Technical Service Bulletin (TSB)

Flash: Powertrain Control Module (PCM) Updates

REFERENCE:	TSB: 18-008-24 GROUP: 18 - Vehicle Performance	Date:	January 25, 2024	REVISION:	18-055-22 REV. A
VEHICLES AFFECTED:	2020 (DD) RAM 3500 Cab Chassis 2020 (DP) RAM 4500/5500 Cab Chassis This bulletin applies to vehicles equipped with a 6.7L I6 Cummins Turbo Diesel Engine (Sales Code ETN).			MARKET APPLICABILITY: ☒ NA ☐ MEA ☐ SA ☐ IAP ☐ EE ☐ CH	
CUSTOMER SYMPTOM:	Customers may experience a Malfunction Indicator Lamp (MIL) illumination. Upon further investigation the technician may find one or more of the following Diagnostic Trouble Codes (DTCs) have been set: • P0506-00 - Idle Control System RPM - Lower Than Expected. • P0607-00 - ECU Internal Performance. • P20E8-00 - Reductant Pressure Too Low. • P0301-00 - Cylinder 1 Misfire. • P0302-00 - Cylinder 2 Misfire. • P0303-00 - Cylinder 3 Misfire. • P0304-00 - Cylinder 4 Misfire. • P0305-00 - Cylinder 5 Misfire. • P0306-00 - Cylinder 6 Misfire. • P0299-00 - Turbocharger Underboost. • P1D73-00 - AGS Performance. • P0626 - Generator Field Control Circuit High. • P218F - Reductant No Flow Detected. • P2002 - Diesel Particulate Filter Efficiency Below

Fig. 1

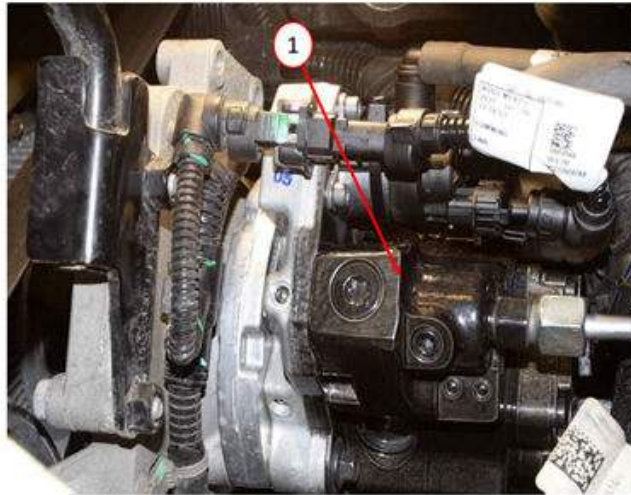
NOTE: The only calibration available will be for the updated CP3.3 design high-pressure fuel injection pump [Fig. 1](#). Please ensure that recall Y78 has been completed first before proceeding with this update.

1. Inspect the high-pressure fuel injection pump [Fig. 1](#) to verify which pump is currently installed on the vehicle. **Also review the vehicle VIP report to see if campaign Y78 has been performed.**

2. Does the VIP report indicate that Y78 has been performed and is the vehicle equipped with the new design fuel injection pump released under the campaign?
 - YES >>> Proceed to [Step 3](#).
 - NO >>> **Perform the Y78 campaign first.** Once the campaign is performed, new pump installed and PCM updated, the PCM will have all of the updates listed in this document. **This Bulletin does not apply.**
3. Reprogram the PCM/ECM with the latest software. Detailed instructions for flashing control modules using the wiTECH Diagnostic Application are available by selecting the application's "HELP" tab.
4. Clear any DTCs that may have been set in any modules due to reprogramming. The wiTECH application will automatically present all DTCs after the flash and allow them to be cleared.
5. Using wiTECH, perform the "Oil Life Restore" procedure located in the ECM "Misc Functions".
